PCN#20200630000.2
New Tray for Select LQFP Devices
Final Change Notification

PCN Number:	20200630000.2	PCN Date:	July 30, 2020
Title:	New Tray for Select Devices		
Customer Contact:	PCN Manager	Dept:	Quality Services
Proposed 1st Ship Date:	Jan. 30, 2021		
Change Type:			
<input type="checkbox"/>	Assembly Site	<input type="checkbox"/>	Design
<input type="checkbox"/>	Assembly Process	<input type="checkbox"/>	Data Sheet
<input type="checkbox"/>	Assembly Materials	<input type="checkbox"/>	Part number change
<input type="checkbox"/>	Mechanical Specification	<input type="checkbox"/>	Test Site
<input checked="" type="checkbox"/>	Packing/Shipping/Labeling	<input type="checkbox"/>	Test Process
<input type="checkbox"/>		<input type="checkbox"/>	Wafer Bump Site
<input type="checkbox"/>		<input type="checkbox"/>	Wafer Bump Material
<input type="checkbox"/>		<input type="checkbox"/>	Wafer Bump Process
<input type="checkbox"/>		<input type="checkbox"/>	Wafer Fab Site
<input type="checkbox"/>		<input type="checkbox"/>	Wafer Fab Materials

Device Fit Analysis:

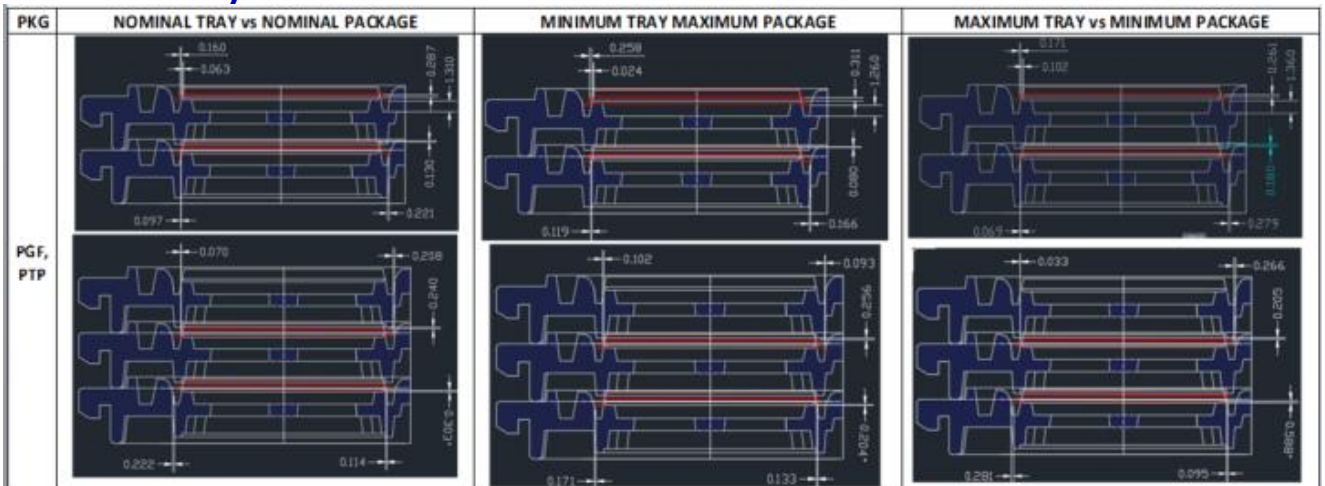
Texas Instruments is pleased to announce the qualification of a new tray for the devices listed below. A comparison summary of the tray differences as follows:

New tray offers improvement on tray warpage, chipping, stuck up caused by current tray
